17 TN 2/2/11 1050/8/2
DE HAVILLAND SERVICE

TECHNICAL NEWS SHEET

INDEX series V (Vampire Airframe, General Circulation)

AMENDED REPAIR SCHEME FOR MAINPLANE
STRINGERS.

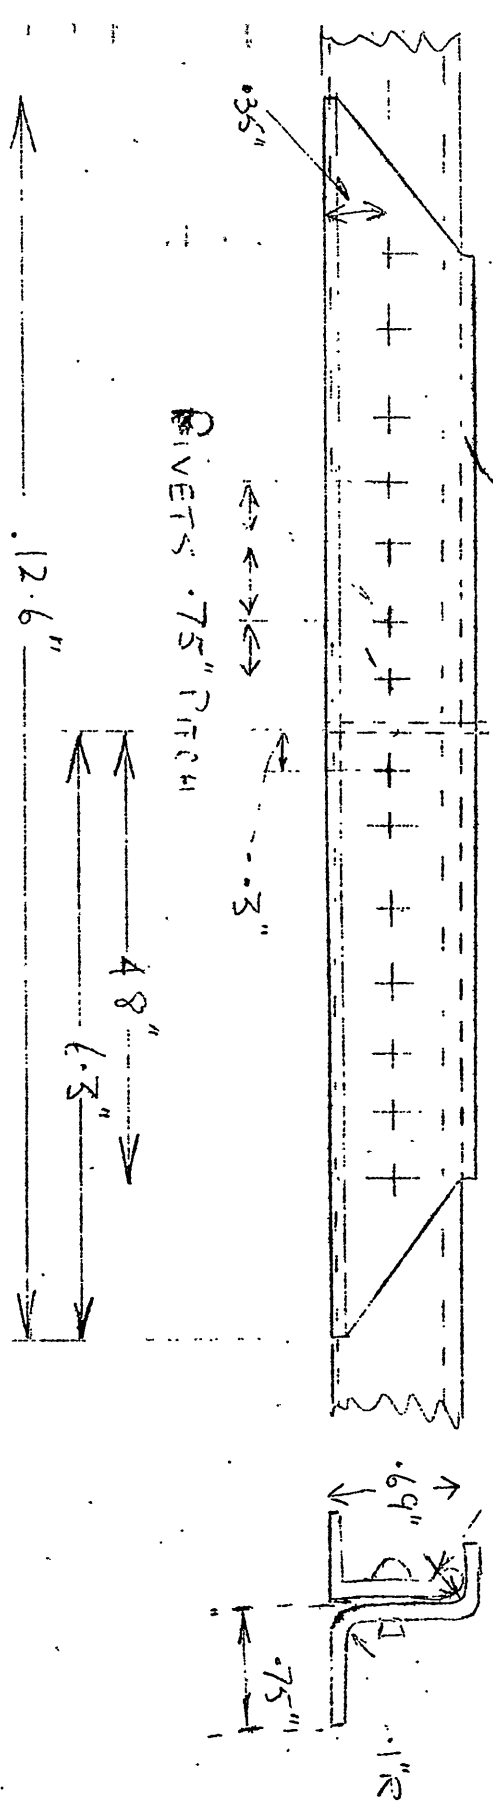
Your attention is drawn to the fact that figure 6/15 of the Vampire Air Publication 4099, Volume 2. Part.3, is to be considered deleted.

A revised Repair is included in this News Sheet, Action is in hand to amend the Air Publication.

FIG 1

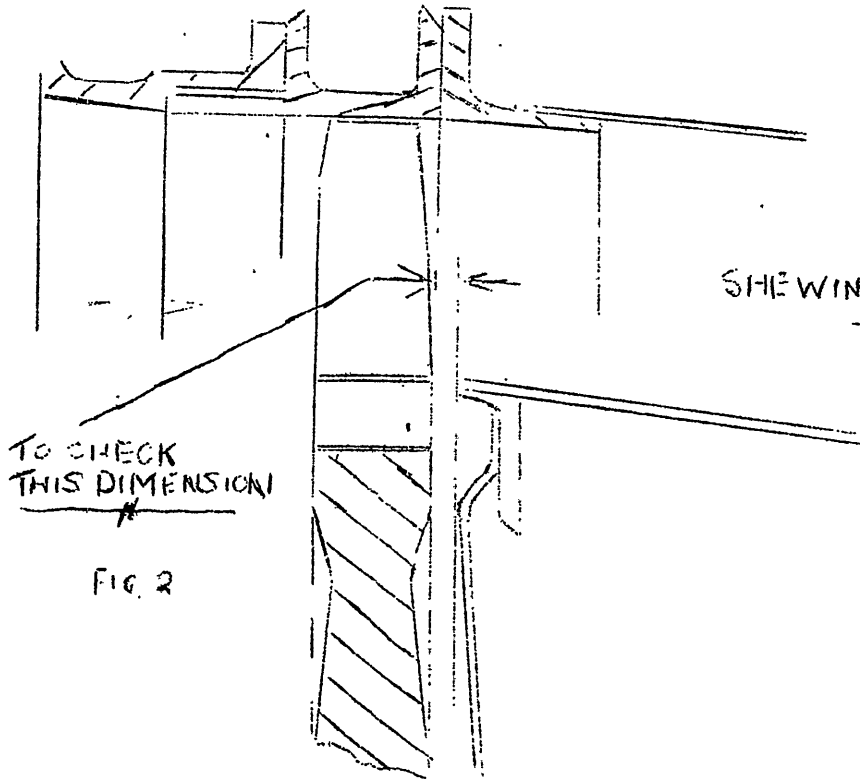
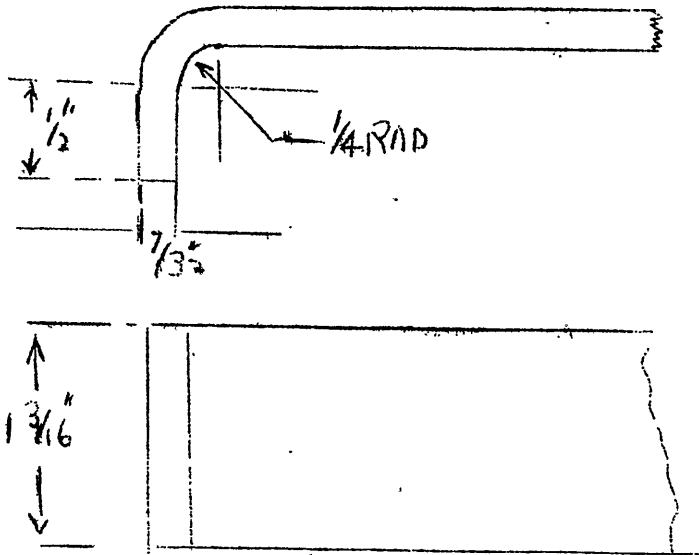
Information has been received of difficulty in checking the clearance between the inner cone and the rear of the turbine disc, due to interference from the balancing rim on the turbine disc.

It has been decided, therefore, to revise the instructions detailed as DAILY INSPECTION in SI/Goblin/2, which is to be amended as follows:-

Para (D) DAILY INSPECTION: Delete this paragraph and Insert new DAILY INSPECTION below:-

"DAILY INSPECTION:- With the aid of a metal gauge manufactured locally to Fig. I (attached), ensure that a safe minimum clearance exists between the rim of the inner cone and the turbine blade root (see Fig II attached),

SKETCH N° 2.

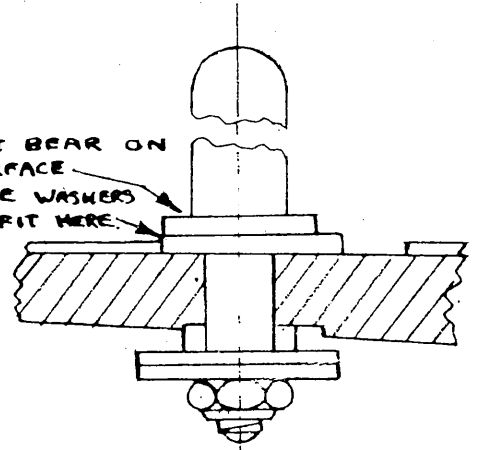
- 1) Remove all rubbers from Edges of Tank fairing.
- 2) Offer up tank to wing and secure nut on suspension bolt. Tighten bolt until Tank is firm on wing. It will be found necessary to use a torque loading of 400 - 500 lbs ins to obtain firmness on wing.

TANK MUST BEAR ON THIS SURFACE
IF NOT REMOVE WASHERS FROM NUT AND FIT HERE

TECALEMIT
SCREW STOP
DRG. NO 150128.

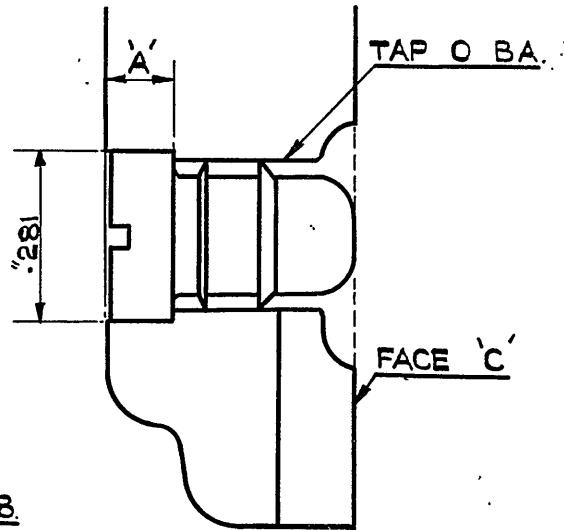
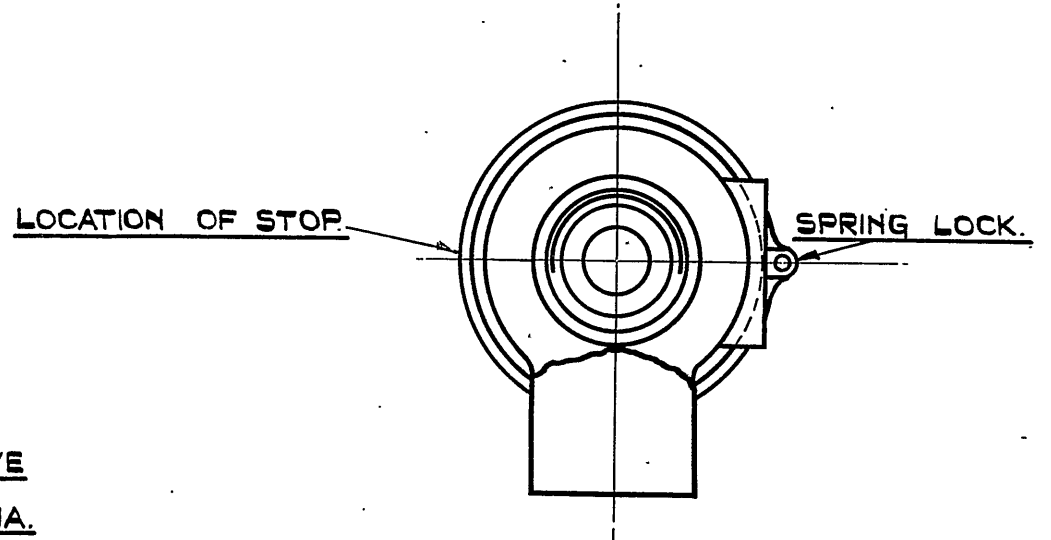
IN CASES WHERE THE FIXED STOP HAS FAILED
& ALLOWED ELEMENT CASE TO ROTATE, THIS
REPAIR IS TO BE CARRIED OUT THE FILTER WILL
THEN BE BROUGHT INTO LINE WITH NEW PRODUCTION.

TAP EXISTING HOLE AS SHOWN ABOVE
THEN COUNTER-BORE 'A' TO 9/32 DIA.
UNTIL THE SCREW STOP END IS LEVEL
WITH FACE 'C'.

ELONGATION OF HOLES IN TOP AND BOTTOM MAINPLANE SKINS.

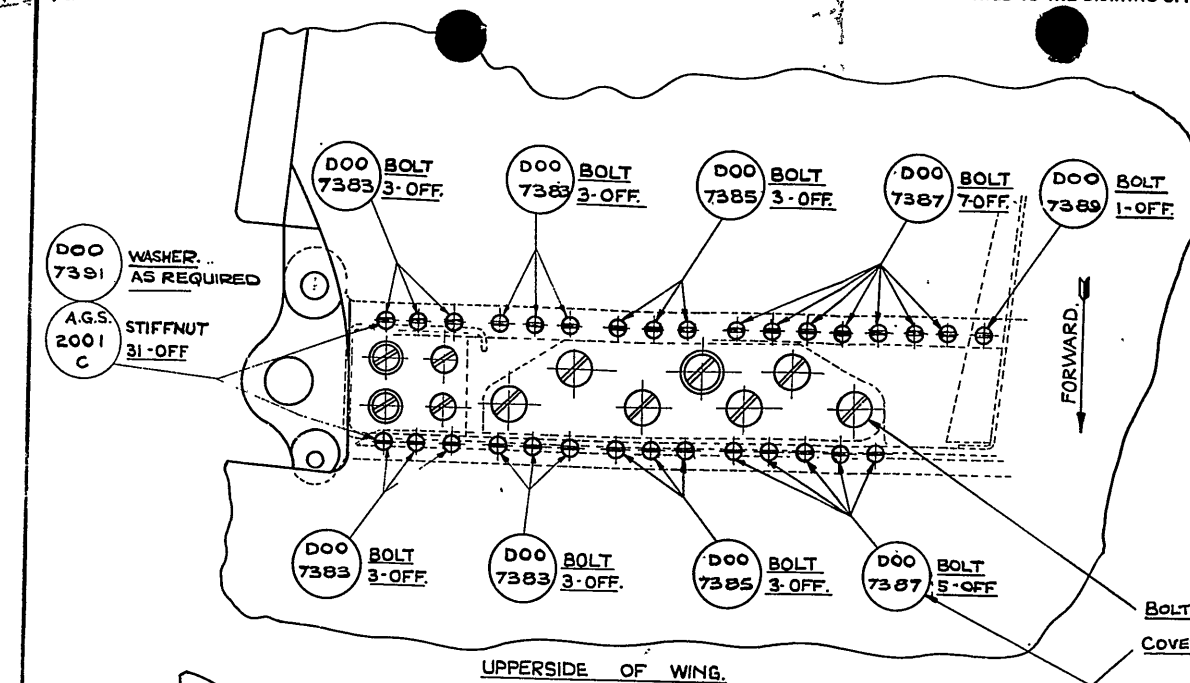
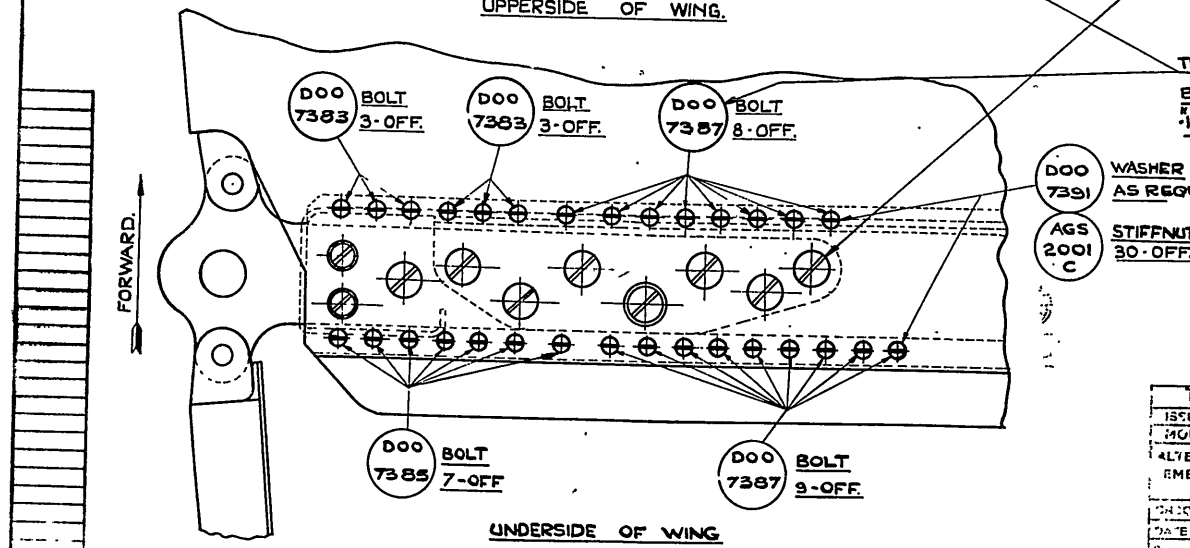
Cases have been reported of elongated holes in top and bottom mainplane skins, adjacent to root end fittings, due to slackness of bolts and rivets securing skin to the main spar booms in the above area becoming loose. In some cases the bolts and rivets will be noticed to be "tilting" towards wing root on the top and towards the tip on the underskin.

At the next Daily Servicing inspect bolts for slackness. If less than 50% of bolts are slack, normal flying is permissible. If more than 50% are found slack, flying is to be restricted to not more than 4G.

CUT-AWAY VIEW OF PORT SIDE
PILOT'S SEAT (MOD. 166)

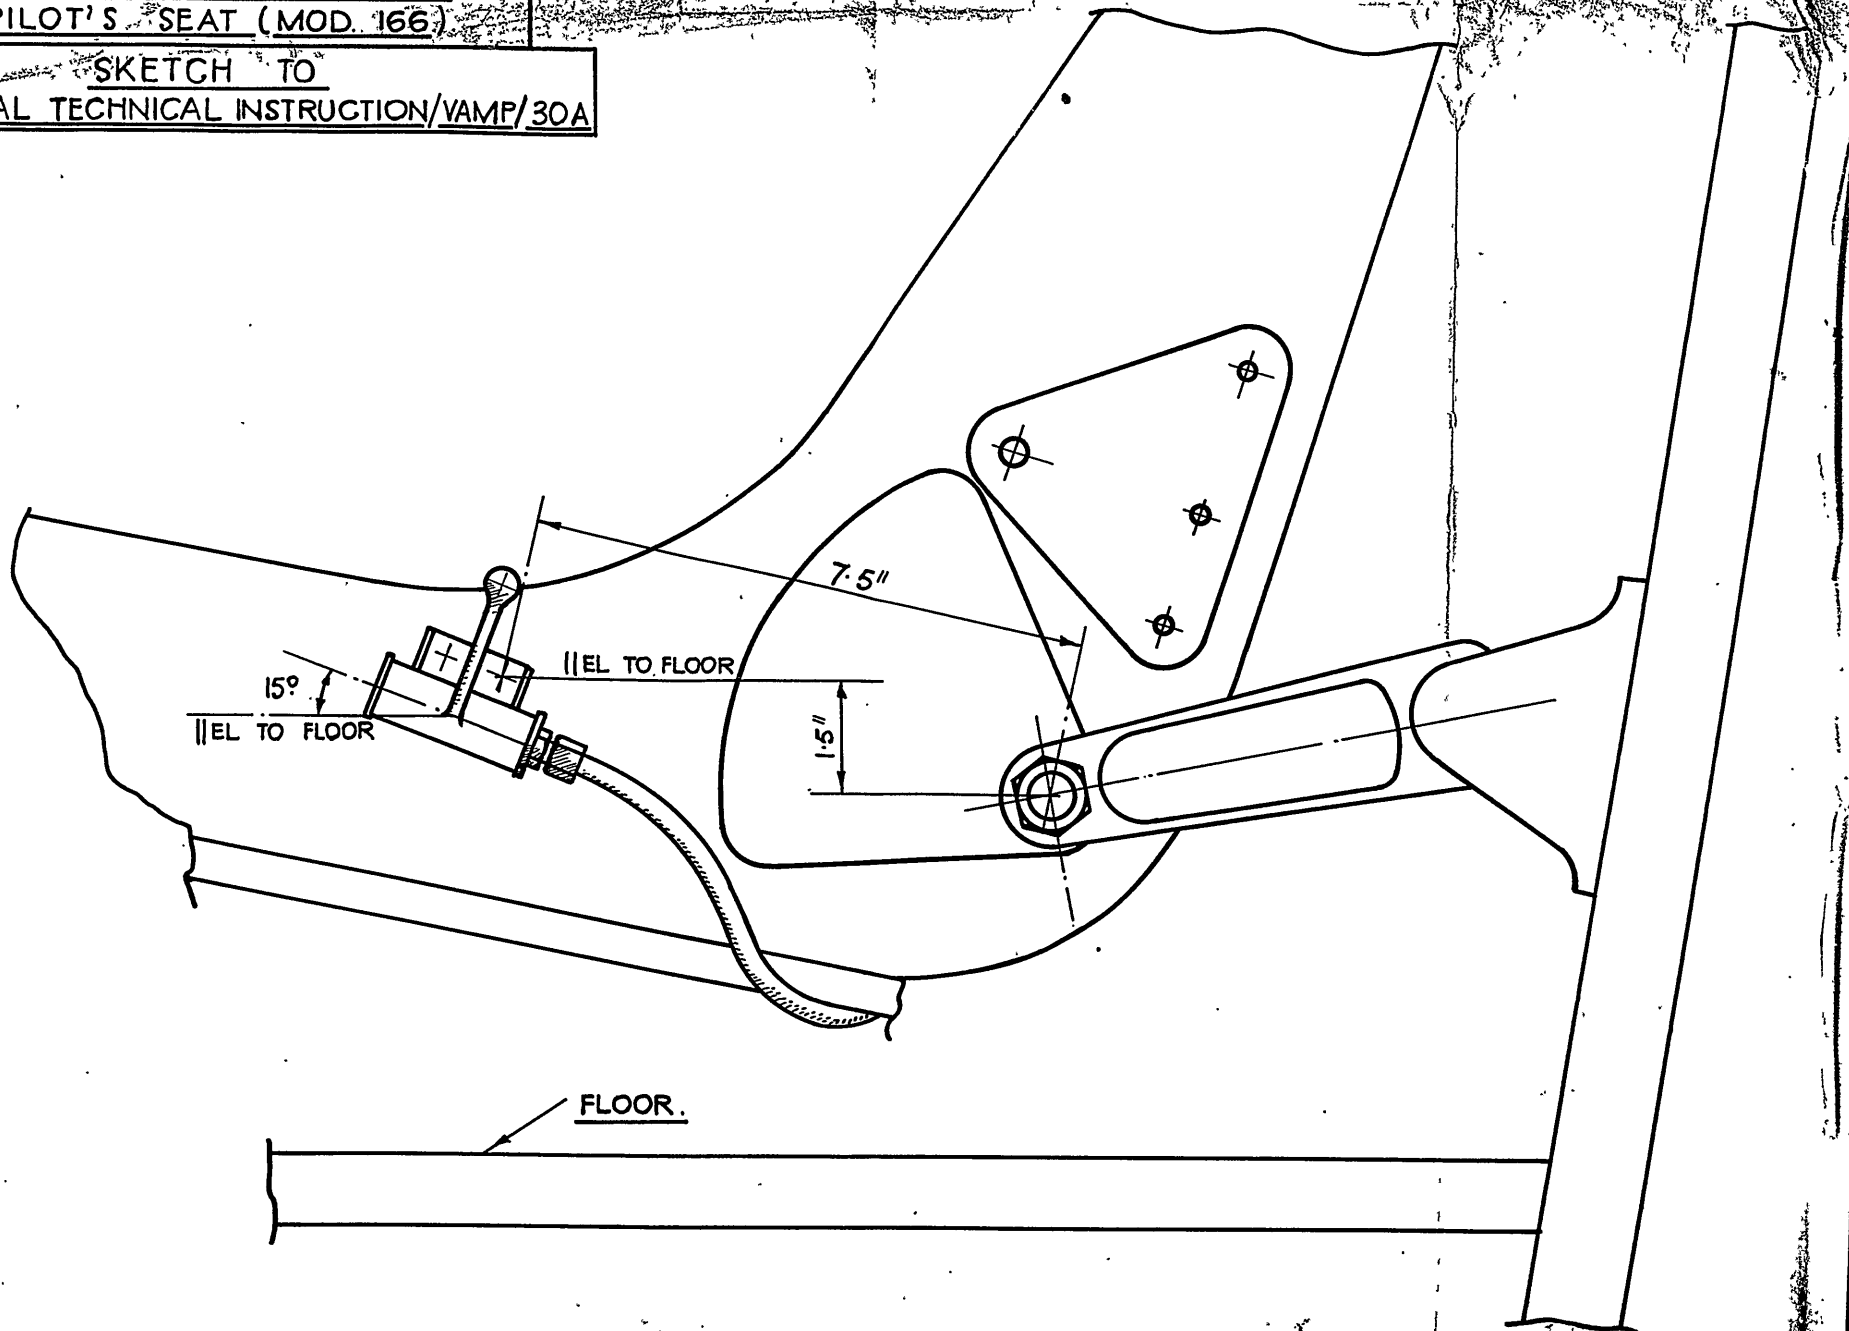
- 6. Replace the lap strap anchorage brackets in a position one rivet pitch lower than originally, using new bolts and nuts Stores Ref. 28D/8310 and 28M/5566 respectively. Burr over ends of bolts to ensure efficient locking of nuts.
 - 7. Drill through port bracket to accommodate upholstery screw and replace screw.
 - 8. Mark out and drill port side of seat to accommodate anchorage release control in position as shown in attached sketch.
 - 9. Replace seat in aircraft and fit anchorage release control in position on port side of seat. NOTE:- Control to be bolted direct to seat, the fibre distance piece to be discarded.
- E. Record on Form 701 (or 1125 as applicable).
- F. Nil.
- G. Vampire/Mod. 782 - Embodiment of this modification will eliminate the need for compliance with this S.T.I.

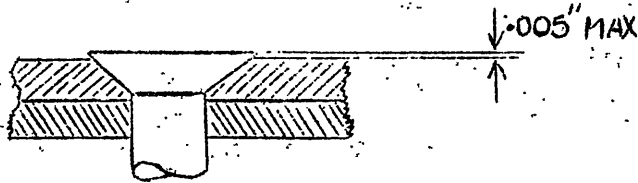
It has been found that serious reduction in yeild strength occurs when rivets are closed with the countersunk head below the surface of the plate. The countersunk or 'Dimple' should be of such depth as to make the rivet head stand slightly proud before riveting up.

The amount not to exceed .005".

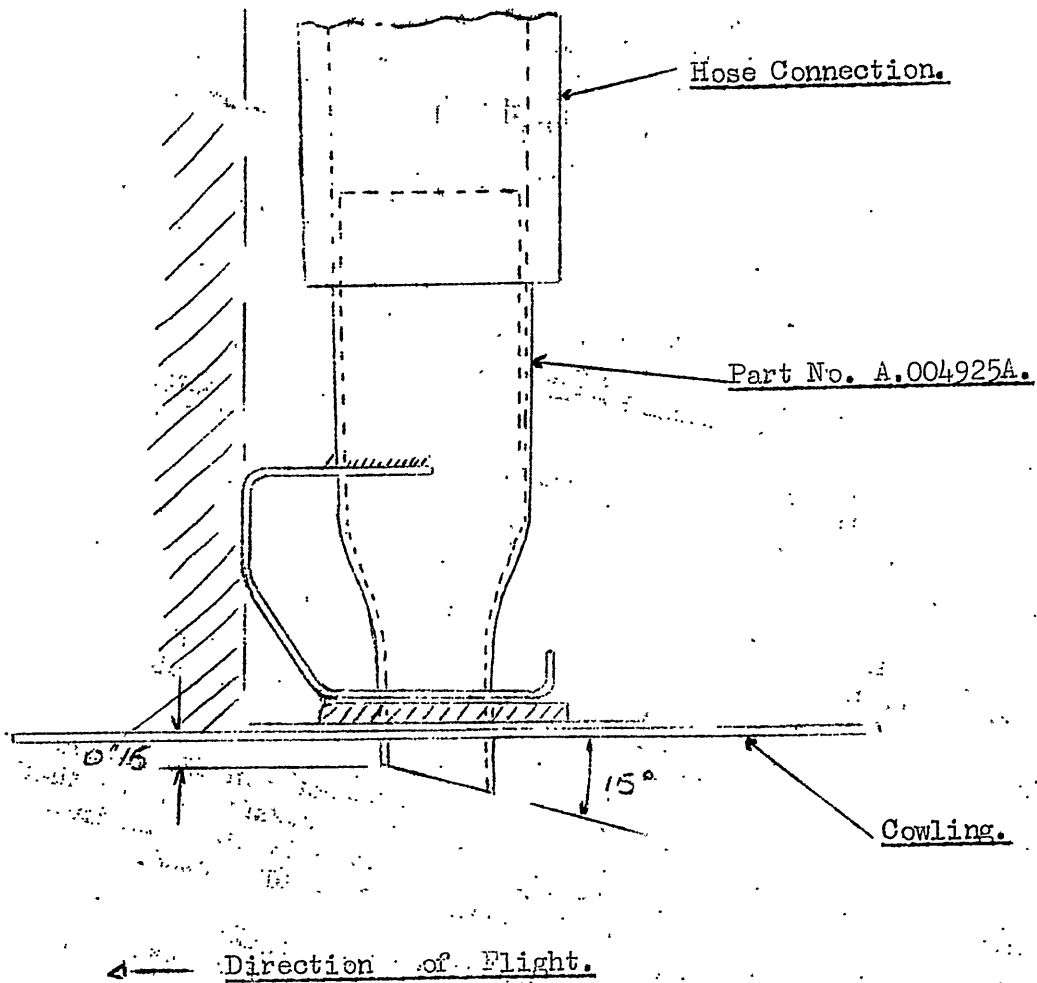
The leaks appear to be due to two different causes:-

1. Weaknesses in the tank. These have been overcome by the addition of strengthening pieces to modification T.18.
2. Flexing of the tanks due to a depression in the tanks under certain conditions of flight. The flexing might cause local strains at the fitting attachments.

Measurements of the differential pressure between the inside of the tank and the tank bay were made, and the results showed that a maximum depression of -0.57 p.s.i. was obtained in the tank in a dive from 25,000 - 10,000 ft. at maximum permissible speed.

Further tests were made on the ground by applying a depression of -0.3 p.s.i. to the inside of a tank installed in a wing. Photographs show very bad distortion of the tank.
